CITY OF CODY
PLANNING, ZONING, AND ADJUSTMENT BOARD
TUESDAY, JANUARY 22, 2019
CITY HALL COUNCIL CHAMBERS @ 12:00 NOON

MEETING DATE:	JANUARY 22, 2018	TYPE OF ACTION NEEDED	
AGENDA ITEM:		P&Z BOARD APPROVAL:	X
SUBJECT:	SITE PLAN REVIEW: WASTEWATER TREATMENT FACILITY PHASE 2 UPGRADES. SPR 2018-26	RECOMMENDATION TO COUNCIL:	
PREPARED BY:	TODD STOWELL, CITY PLANNER	DISCUSSION ONLY:

MEETING DATE:	JANUARY 22, 2019	TYPE OF ACTION NEEDED	
AGENDA ITEM:		P&Z BOARD APPROVAL:	X
SUBJECT:	SITE PLAN REVIEW: HAMPTON INN AND SUITES. SPR 2018-24	RECOMMENDATION TO COUNCIL:	
PREPARED BY:	TODD STOWELL, CITY PLANNER	DISCUSSION ONLY:

GRADING PLAN

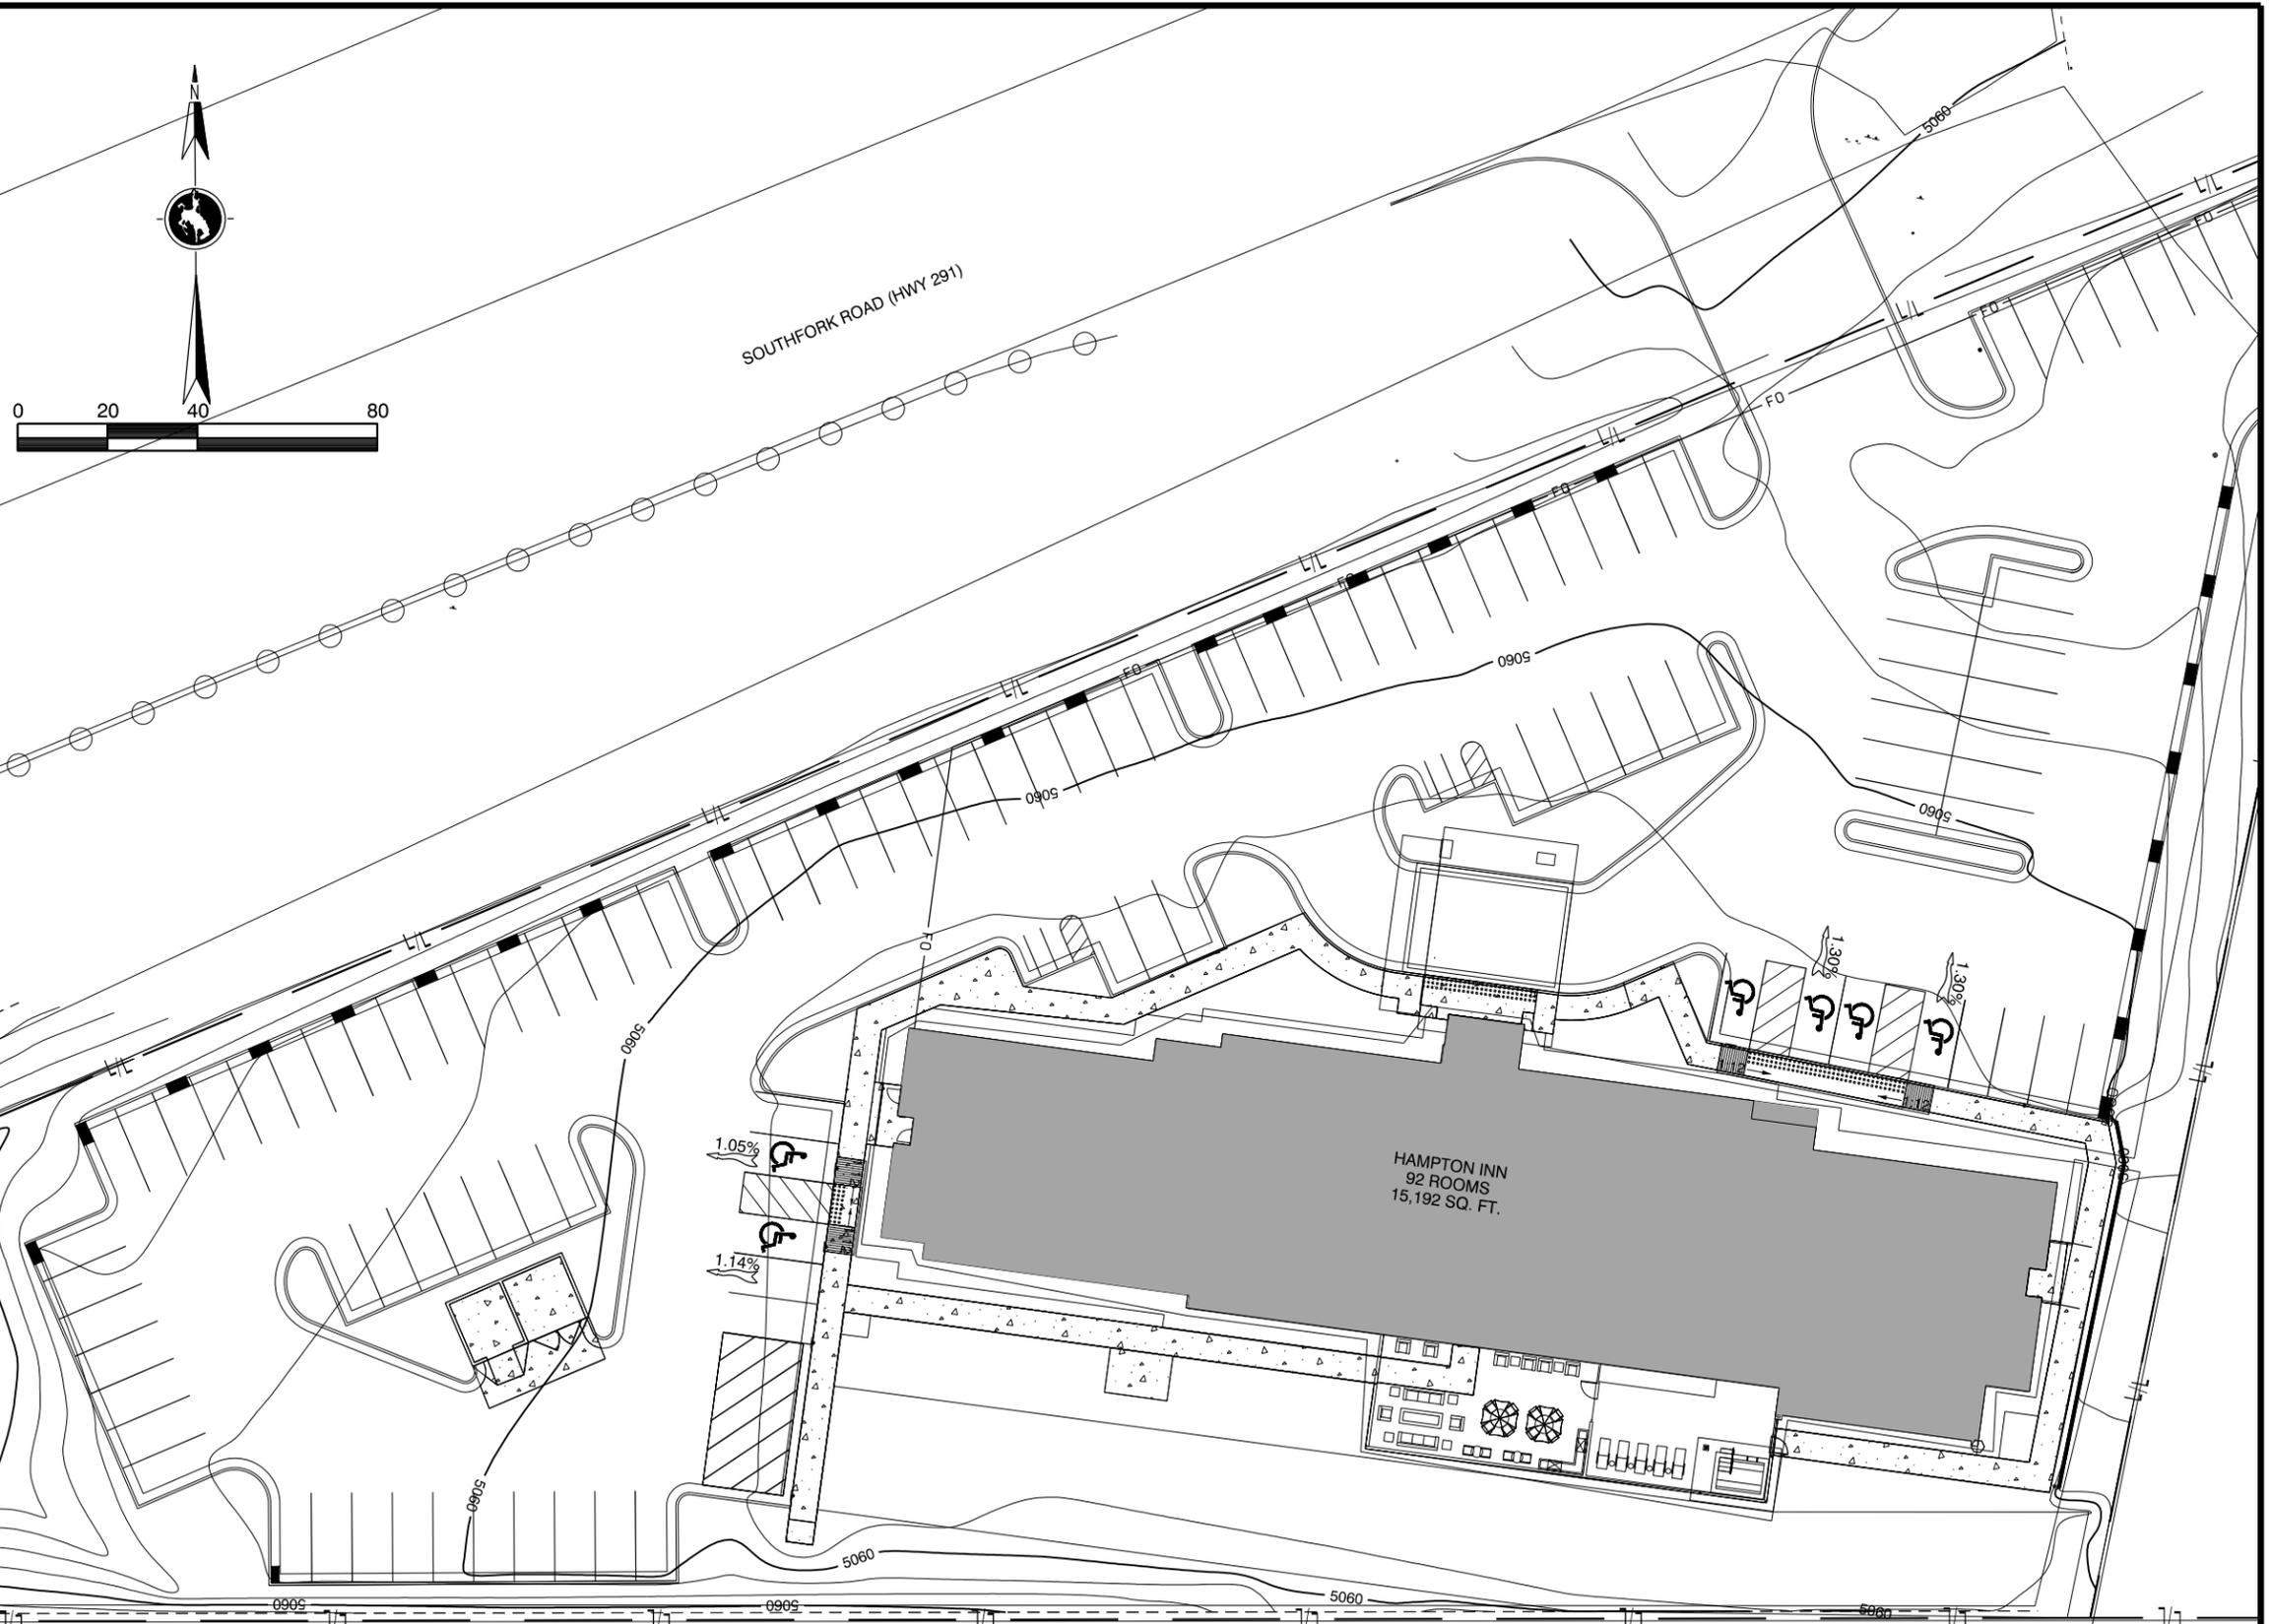
An analysis of the storm water was provided by the applicant's engineer. The storm water will be managed as noted in the grading and drainage plan (Sheets 3 and 4) and storm water report. Much of the parking area will be graded to a created rock-lined stream bed along the northwest side of the property, where it will flow at 0.5% to an infiltration basin at the southwest end of the property. Water from the roof will be collected through internal piping, out the east end of the building, down along the south property line to the infiltration basin. That pipe will also be used to discharge water from the swimming pool and hot tub when maintenance necessitates.

Currently, there is land at the bottom of the highway slope to fit a trail. However, the grading plan apparently shows the infiltration basin tying into the highway slope so that no flat area would remain. The City requests that a minimum 10-foot wide strip of flat land remain within the WYDOT right-of-way southwest of the entrance to the south property line. If the Board agrees, we will relay that request to WYDOT to consider in

7. Provide a detail for the curb cuts.
8. Clearly show a drainage ditch or method of conveying storm water along the south property line to the infiltration basin.

SITE PLAN - ELECTRICAL
E1.0

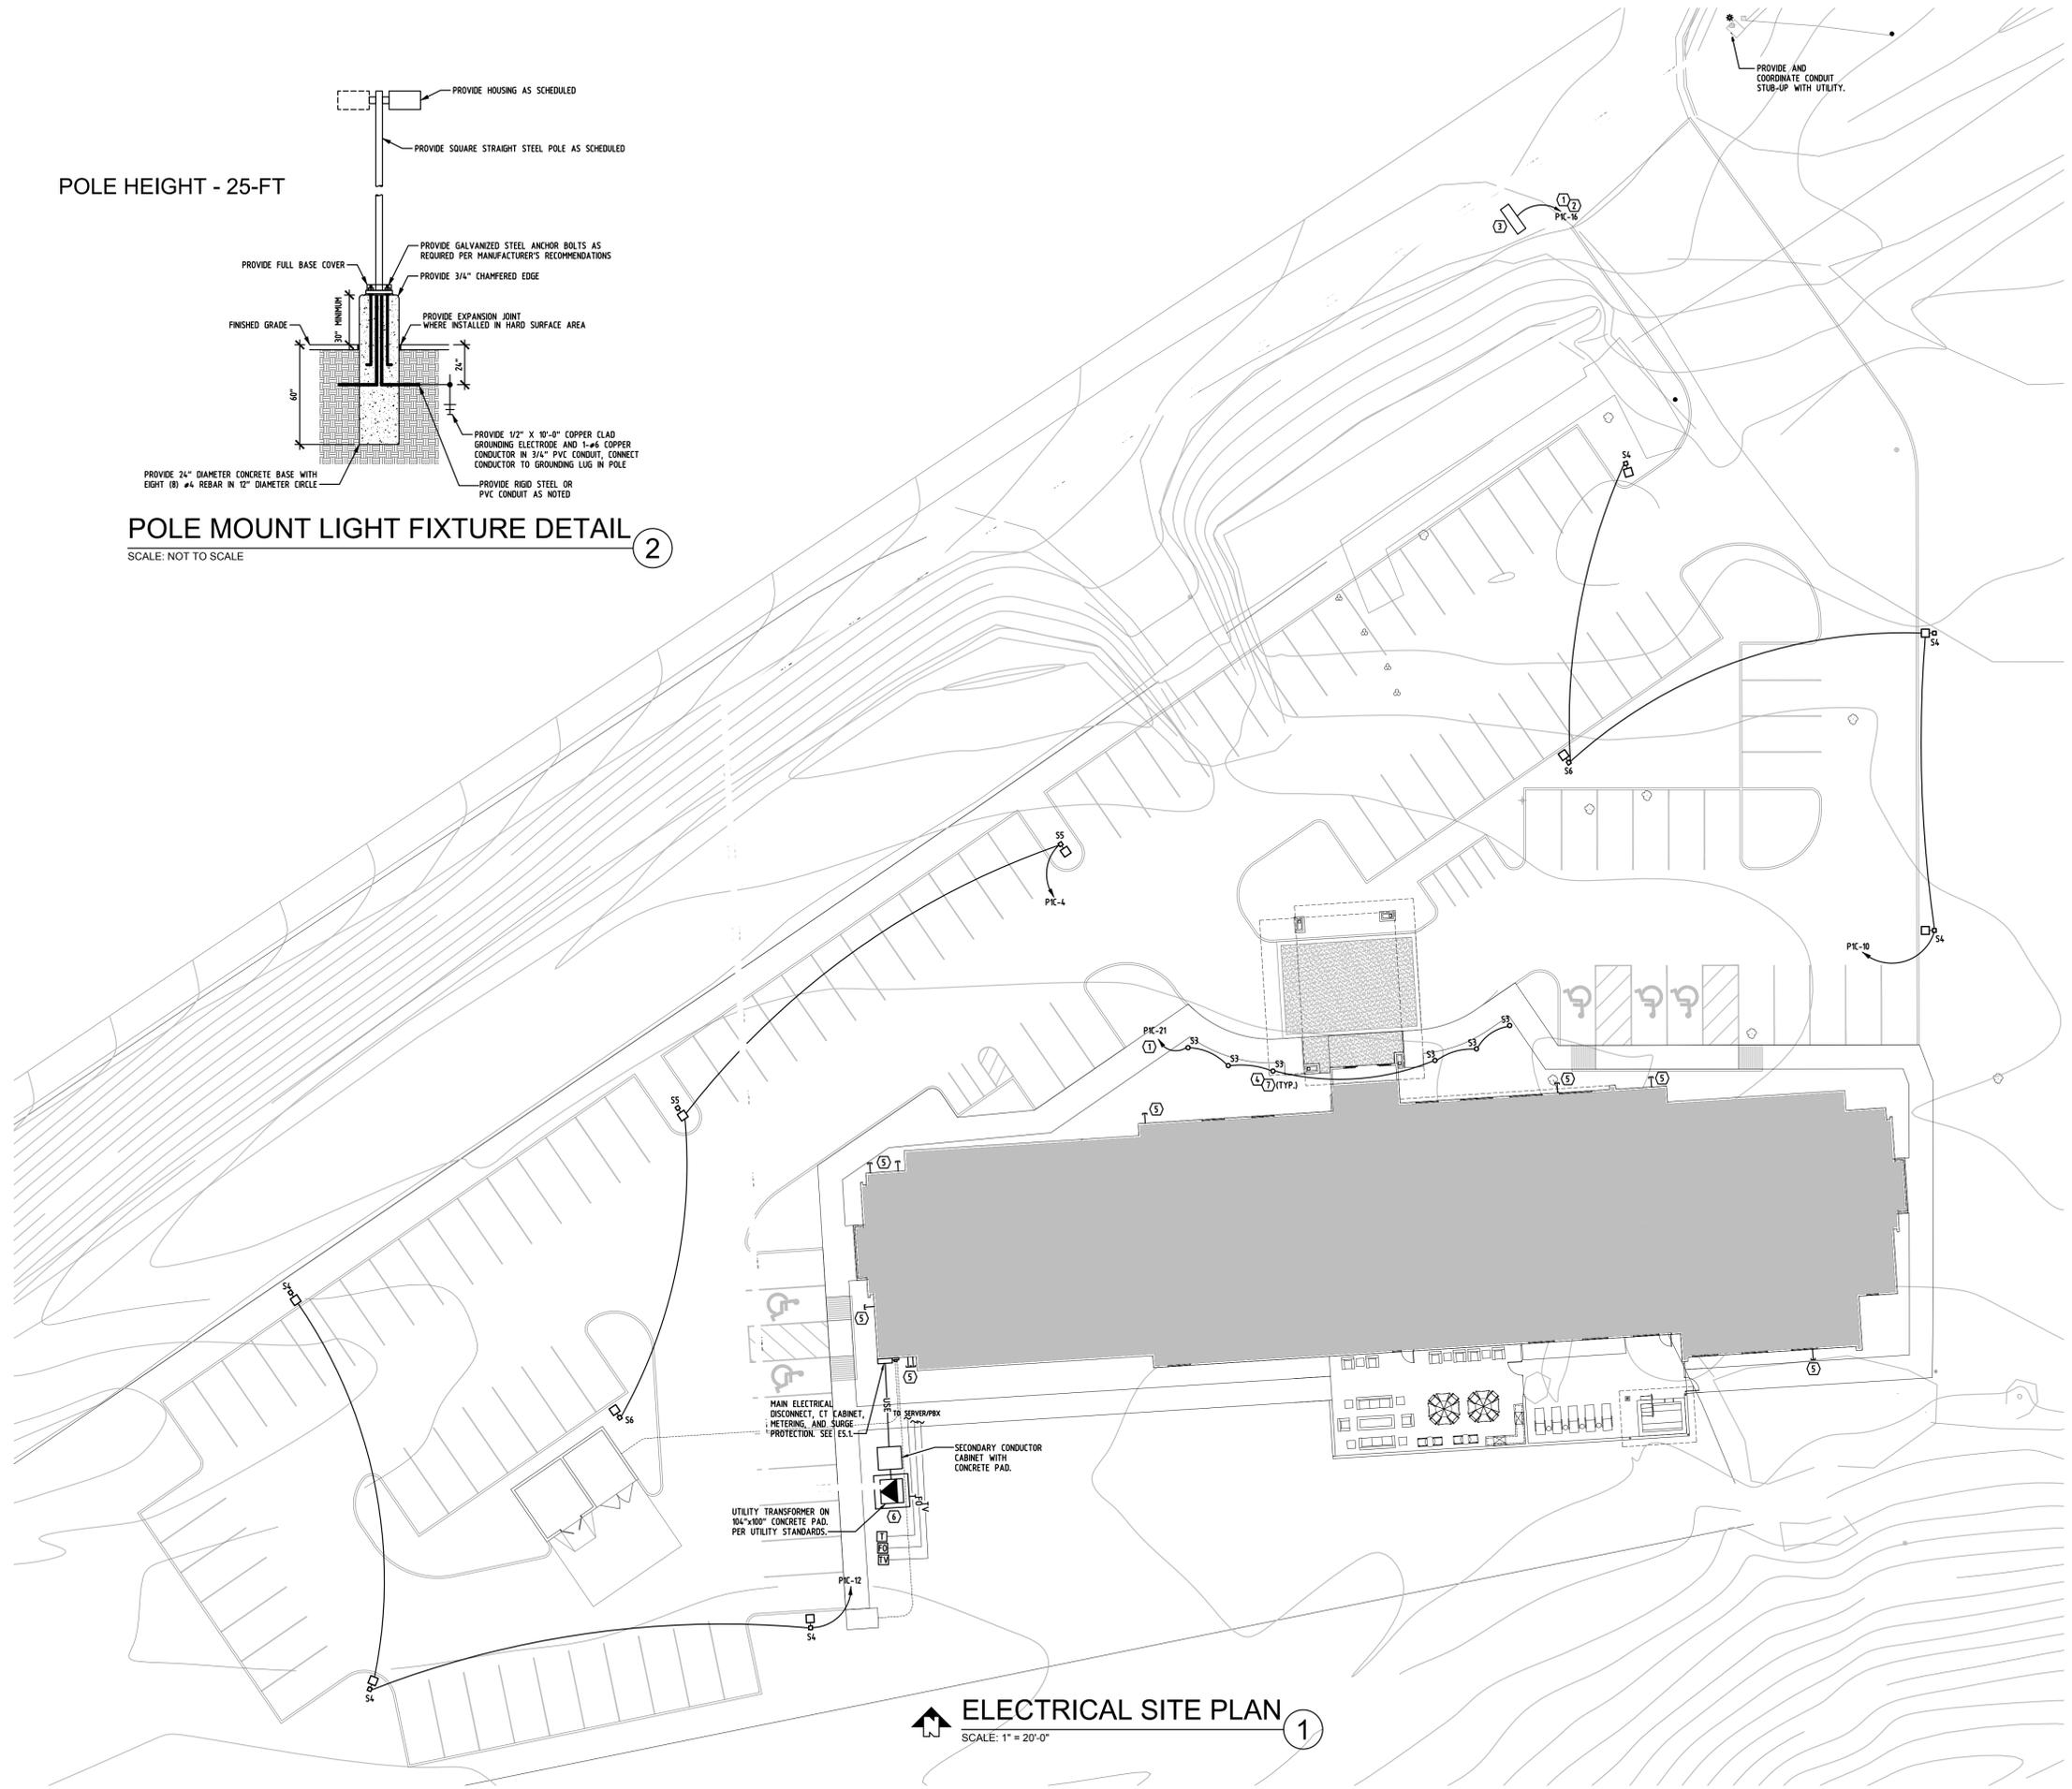
Lighting details are provided on Sheets E1.0, E1.1, and the photometric plan (shows illumination levels across site in foot candles). The lighting plan has not been updated to reflect the reconfigured parking area on the northeast end of the project.

The electrical service work has been coordinated with the City, and estimates for materials provided to the applicant. It is noted that Sheet E1.0 has the transformer and other utility boxes in the wrong place—that location conflicts with the fire lane access along the south of the project. Sheet 5 shows the proper transformer location, but lacks the other utility boxes.

A sign application is not included. The exterior signage will require review and permitting at the staff level. It is noted that the monument sign location shown on Sheet E1.0 is in the WYDOT right-of-way, which is not authorized at this time and is doubtful it will be authorized by WYDOT.

14. Update Sheet E1.0 and E1.1 to detail the correct transformer and utility box locations, reflect the modifications to the parking lot in the northeast area, and remove the monument sign from the WYDOT right-of-way (unless permitted otherwise by WYDOT).
